Lamps, Reflective Devices, and Associated Equipment

ACTION: Final rule.

SUMMARY: This notice amends the trailer conspicuity requirements of Motor Vehicle Safety Standard No. 108 to provide clarifications of the existing rule with respect to tank trailers and to the width of retroreflective conspicuity sheeting.

Figure 30-1
Trailer Conspicuity Treatment Example

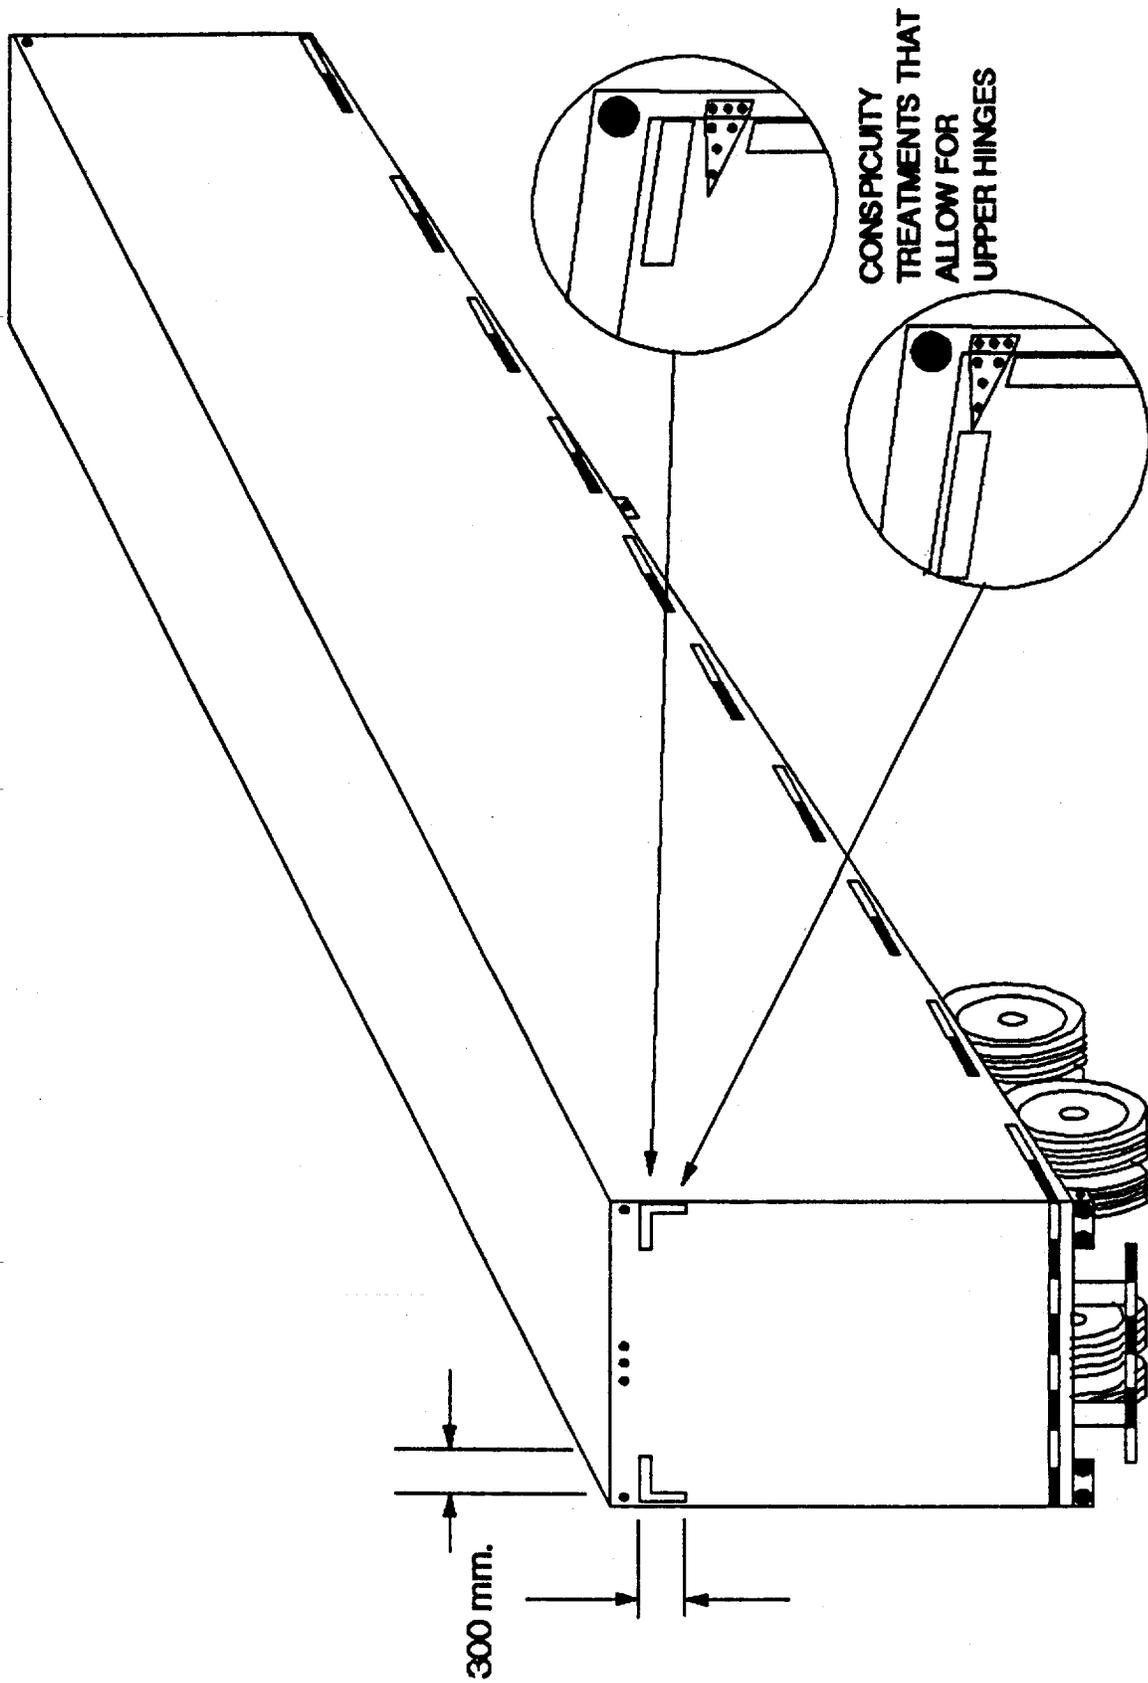
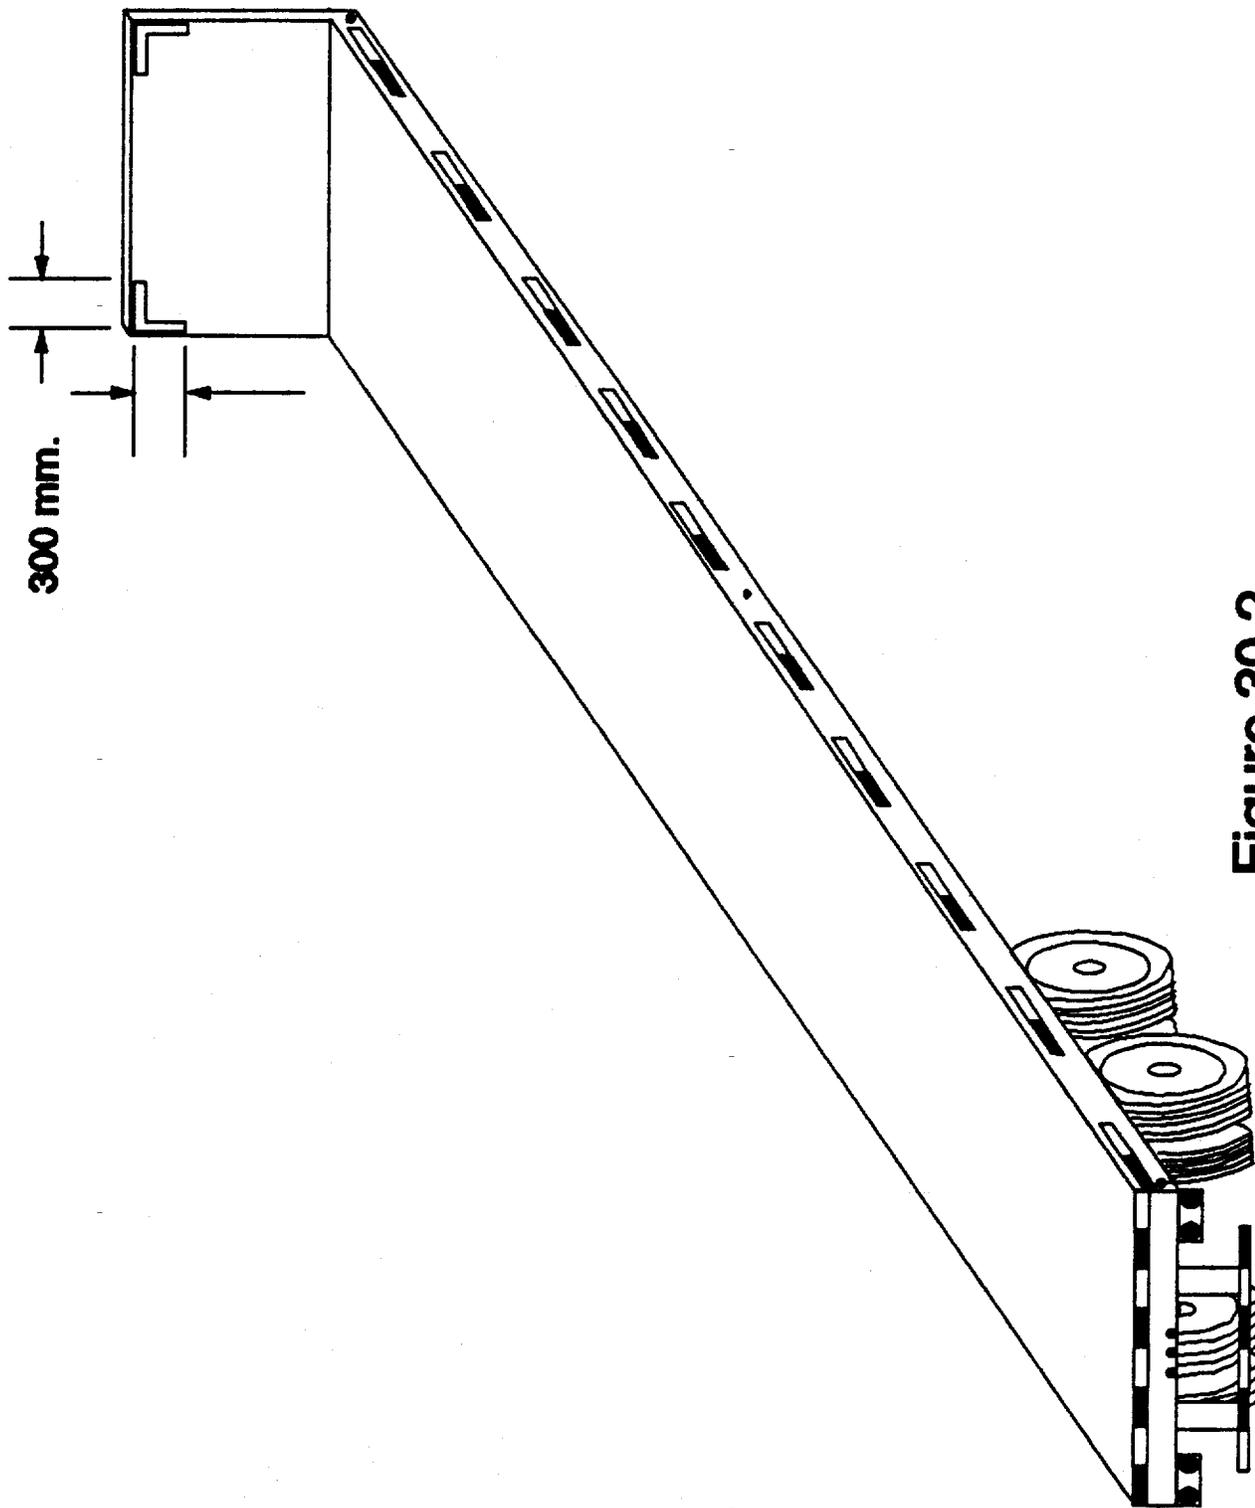
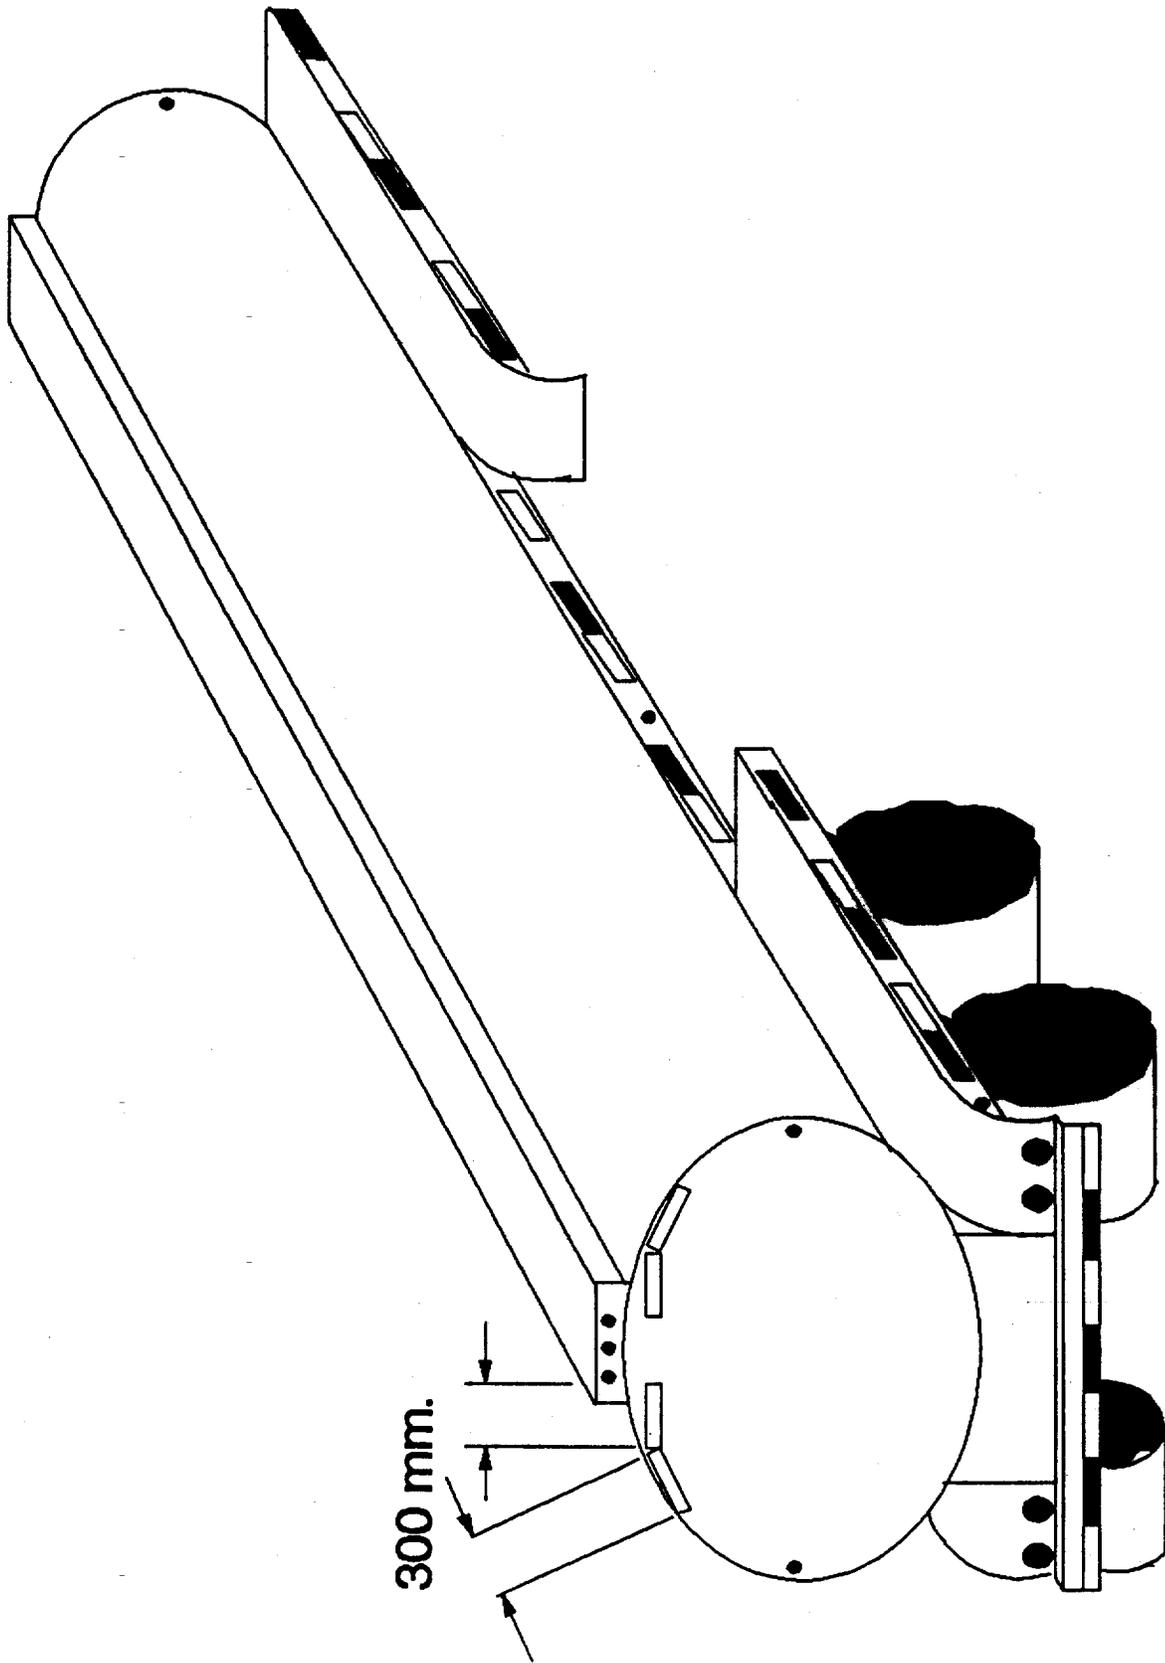
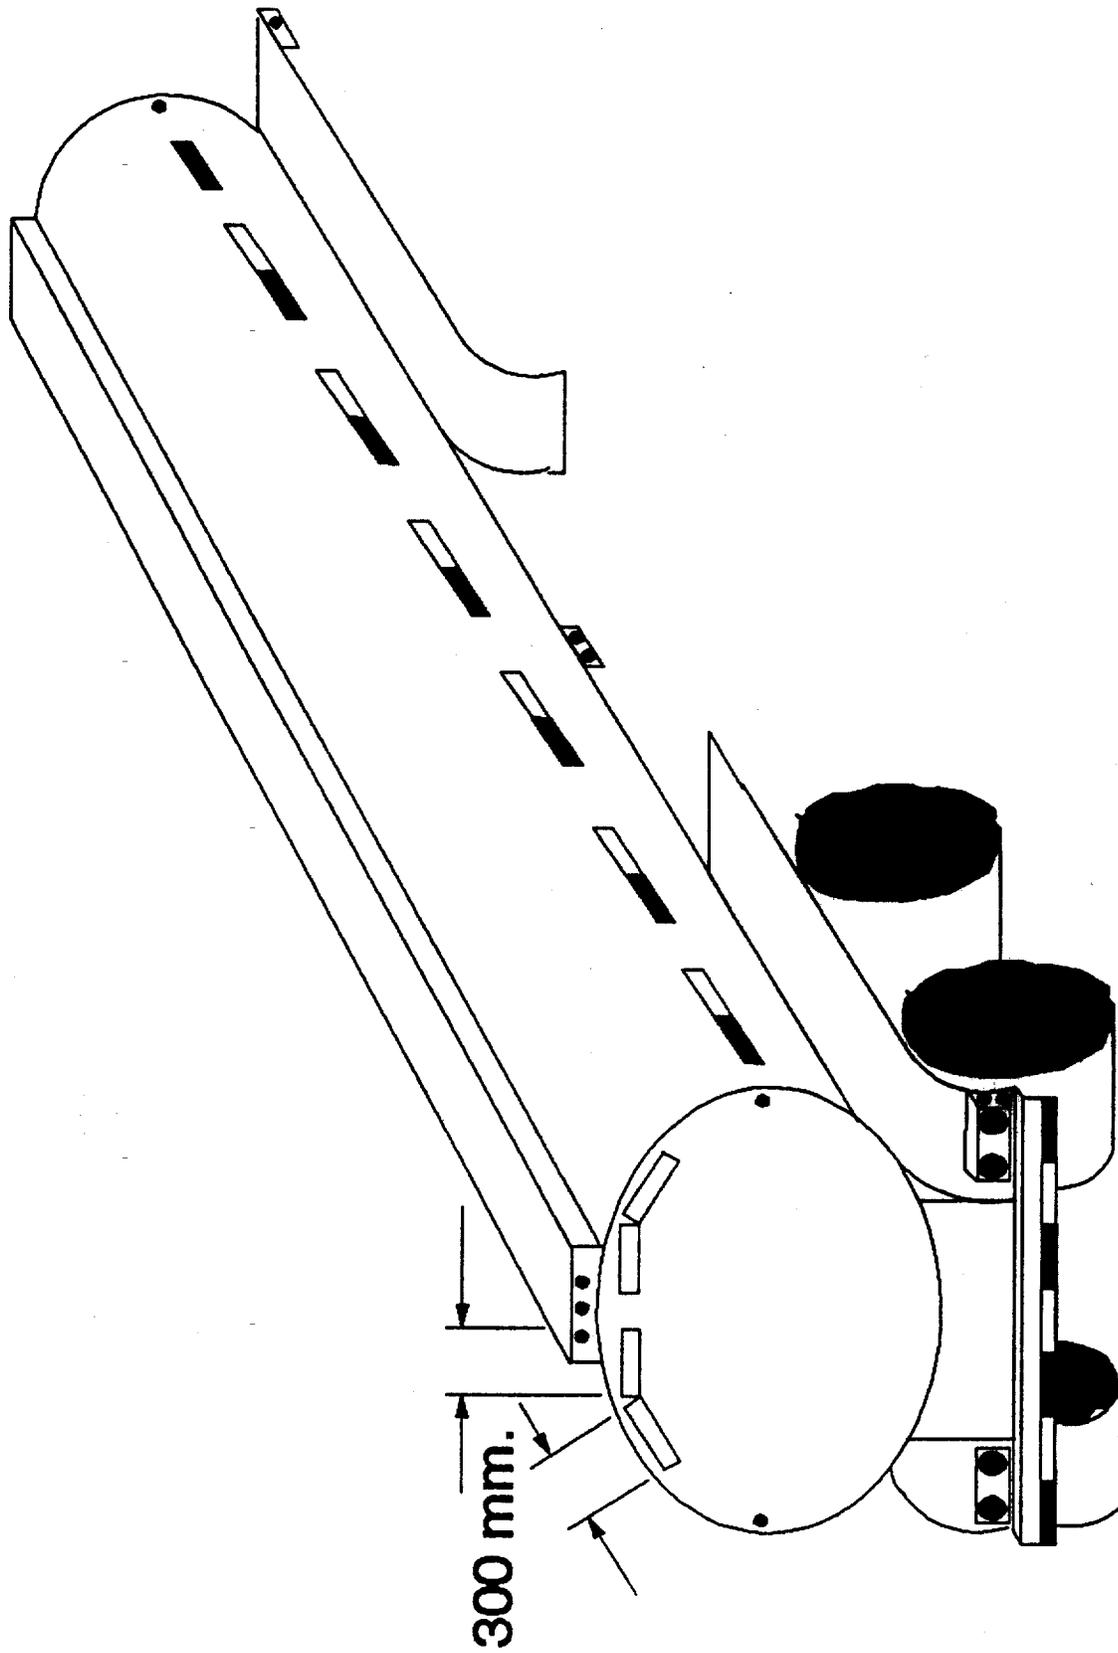
Figure 30 shows a side stripe with two breaks to illustrate that the side stripe is not required to be continuous. This Figure has been interpreted literally by some small manufacturers as requiring three long pieces of material. NHTSA is replacing Figure 30 with four drawings (Figures 30-1 through 30-4) which are more realistic. They include two examples of tank trailers which illustrate interpretations that side material may be mounted at the tank centerline when practicable locations closer to the ground are unavailable, another source of questions from tank trailer manufacturers. The new Figure also shows other required lamps and reflectors, which had not been illustrated in the original Figure 30.

3. Section 571.108 is amended by removing Figure 30 and adding Figures 30-1 through 30-4 as set forth below:

(a) Retroreflective sheeting shall be applied in a pattern of alternating white and red color segments to the side and rear of each trailer, and in white to the upper rear corners of each trailer, in the locations specified in S5.7.1.4, and Figures 30-1 through 30-4, as appropriate.
